Access Compliance Report

Public Rights-of-Way

Intersection ID: 19817	Main Street: MONROE_RD	Cross Street: TIMBER_SPRINGS_DR	Location: N
ADA ID: E2B48DE294C7	Ramp Type: Perp	Initial Pass/Fail: Fail	Overall Compliance: No
			Severity Score: 13.75

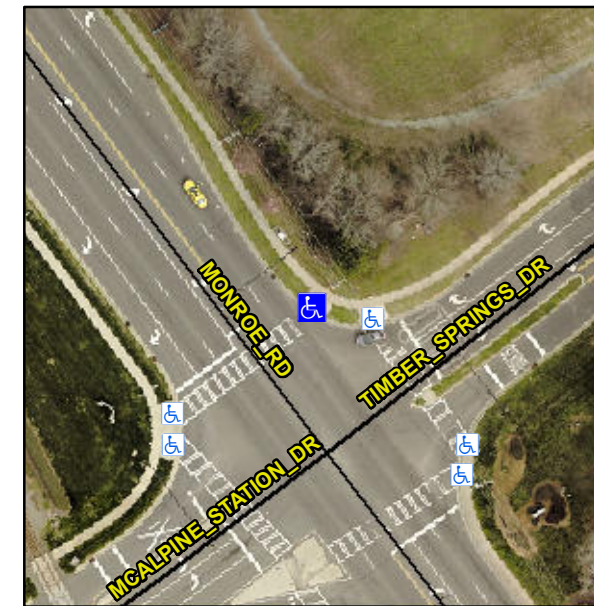
R304.2.2, R304.5.3

Compliance	Description	Data	Compliance	Description	Data
N/A	Ramp Length (in)	93.0	No	Ramp Slope (%)	8.6
Yes	Ramp Width (in)	48.0	No	Ramp XSlope (%)	2.8
N/A	Flare Type LT	N/A	N/A	Flare Type RT	N/A
N/A	Flare Slope LT (%)	N/A	N/A	Flare Slope RT (%)	N/A
N/A	Flare Traversable LT?	N/A	N/A	Flare Traversable RT?	N/A
N/A	Landing Length (in)	N/A	N/A	DWS Provided?	N/A
N/A	Landing Width (in)	N/A	N/A	DWS Contrast?	N/A
N/A	Landing Slope (%)	N/A	N/A	DWS Length (in)	N/A
N/A	Landing X Slope (%)	N/A	N/A	DWS Full Width?	N/A
N/A	Landing Curb? (Y/N)	N/A	N/A	DWS Offset (in)	N/A
N/A	Shared Landing?	N/A			
N/A	Gutter Ponding?	N/A	N/A	Gutter Slope (%)	N/A
N/A	Gutter Lip Ht (in)	N/A	N/A	Gutter X Slope (%)	N/A
N/A	Painted X Walk1?	Yes	N/A	Painted X Walk2?	N/A
	X Walk 1 Direction	To SW		X Walk 2 Direction	N/A
N/A	X Walk 1 Width (in)	116.0	N/A	X Walk 2 Width (in)	N/A
	X Walk 1 Slope (%)	4.4		X Walk 2 Slope (%)	N/A
	X Walk 1 X Slope (%)	0.7		X Walk 2 X Slope (%)	N/A

Remove & Replace Entire Ramp.
